**CULTURAL RESOURCES OFFICE
 PRESERVATION BOARD
 REGULAR MEETING
 MONDAY SEPTEMBER 22, 2014 — 4:00 P.M.
 1520 MARKET ST. #2000
 ST. LOUIS, MISSOURI 63103
www.stlouis-mo.gov/cultural-resources**

DATE: September 22, 2014
ADDRESS: 2124 Victor Street
ITEM: Appeal of Director's Denial to replace a slate roof
JURISDICTION: Benton Park Local Historic District — Ward 9
STAFF: Andrea Gagen, Preservation Planner, Cultural Resources Office

DATE: September 22, 2014
ADDRESS: 5149 Westminster Place
ITEM: Appeal of Director's Denial to replace front porch balustrade and columns
JURISDICTION: Central West End Local Historic District — Ward 28
STAFF: Bob Bettis, Preservation Planner, Cultural Resources Office

DATE: September 22, 2014
ADDRESS: 2400-2408 S. 9th Street
ITEM: Appeal of Director's Denial of Exterior alterations to a Public Facade
JURISDICTION: Soulard Neighborhood Certified Local Historic District — Ward 7
STAFF: Andrea Gagen, Preservation Planner, Cultural Resources Office

ORIGINAL AND PROPOSED CAPITAL

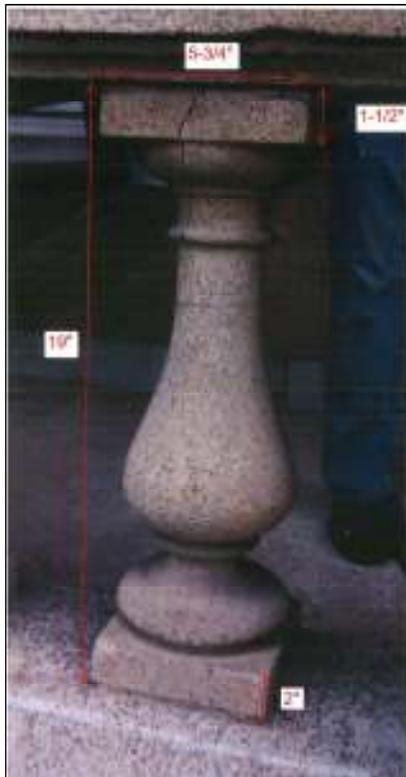
- The wood columns have been examined in the field and need only cosmetic maintenance to remain in service.
- The proposed replacement fiberglass columns and capitals do not do not replicate the existing elements. The capitals are smaller in size than the original, of a different material and do not have the same design as the original. The new columns do not have the ornamentation at the neck or the same entasis as the original columns.

PROPOSED WEST ELEVATION

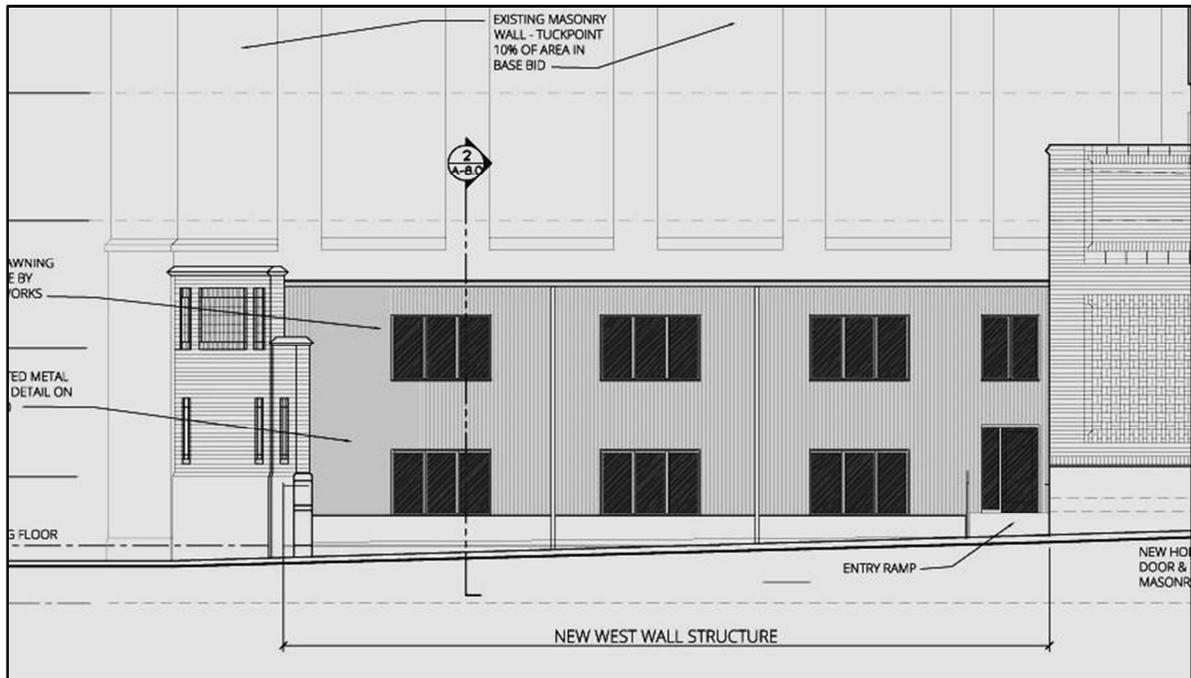
The windows originally proposed for the reconstructed loading bay area were wide windows with a residential character; this design has been revised at the request of the Cultural Resources Office and the new wall now displays taller, triple windows with proportions that more closely aligned with those of the adjacent office building.

- The use of corrugated sheet metal proposed for the reconstructed loading dock area does not meet the standards but could be considered an appropriate material in this instance, as the original use of the property was industrial. The design of the fenestration of this portion of the complex has been revised to be more compatible with the other openings in the complex, to be in line with the intent of the Soulard Neighborhood Local Historic District Standards.

Based on these preliminary findings, the Cultural Resources Office recommends that the Preservation Board overturn the Director’s denial of the application based upon the revised west elevation, and subject to the condition that final plans and exterior materials will be reviewed and approved by the Cultural Resources Office.

DETAIL OF ADDITION

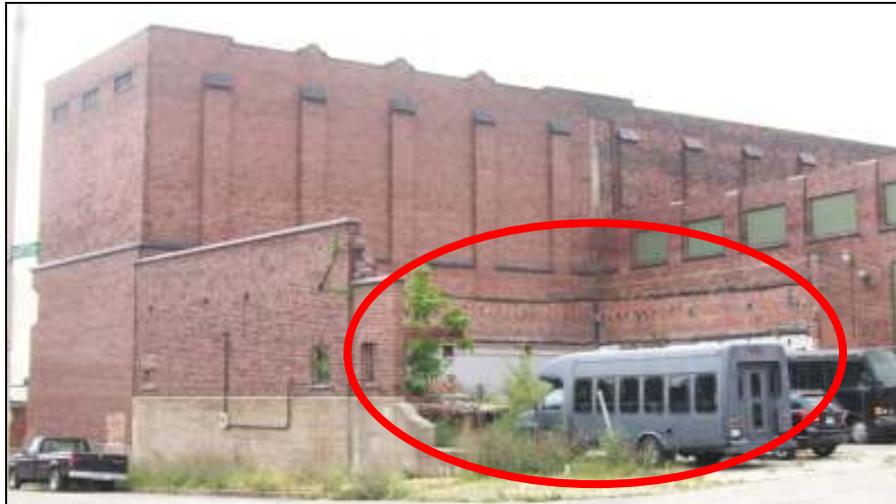
Does not comply. The reconstructed wall at the loading dock area, along with a new roof, will enclose occupied space. Remnants of the original wall of the loading dock enclosure at this location show that it was brick. The reconstructed wall is proposed to be faced with corrugated sheet metal. In discussion with the project architect, it was found that adding brick to this elevation would add approximately \$12,000 to the costs of the project. The corrugated sheet metal is a material associated with industrial buildings and may be appropriate for this property. The architect has agreed that the metal will be dark gray and have a matte finish.
